28th January, 1960.

"WAYNEGATE".

I refer to Liverpool Rpt.8. No.153379 regarding this ship, about which you may remember I 'phoned in connection with the attachment of keel plates to garboard.

SECTION.

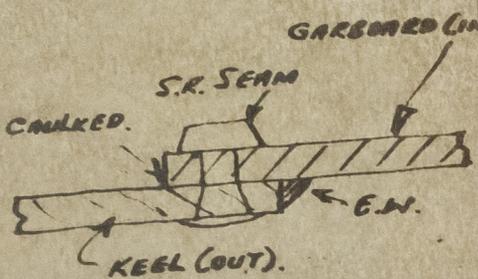
I have reported a couple of keel plates forward renewed "as originally" and should say that the keel plating is attached to the garboard by a combination of single riveting and electric welding, as per sketch. This does not tie in with what you told me on the 'phone where the midship section and F.E. Rpt. indicated D.R. seams, and I think perhaps you would like to correct the records privately for this ship in case of future queries about the keel plate renewals.

From the sketch you will see that the present renewals have been made with the welding on the outside instead of inside with a view to preventing the tendency to spring open on the sight edge, the inside edge being caulked so far as possible between floors.
